Following is a correction to the recommended land pattern in the databook:

- Radio-Frequency Semiconductors Diodes
- Document ID: BDE0003D
- Published in 2006-9

(16) SMQ

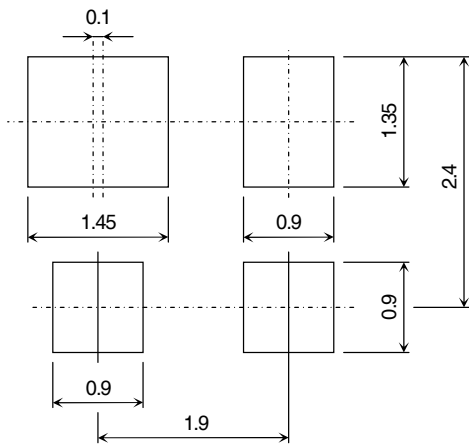
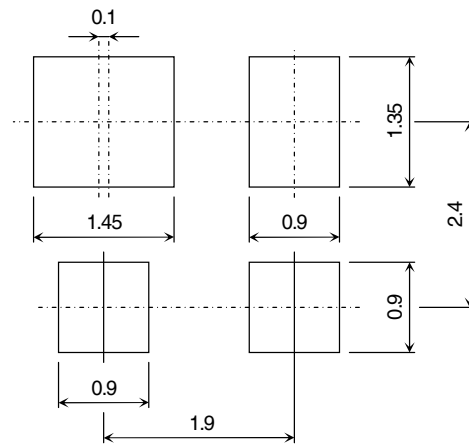
Wrong:

Right:
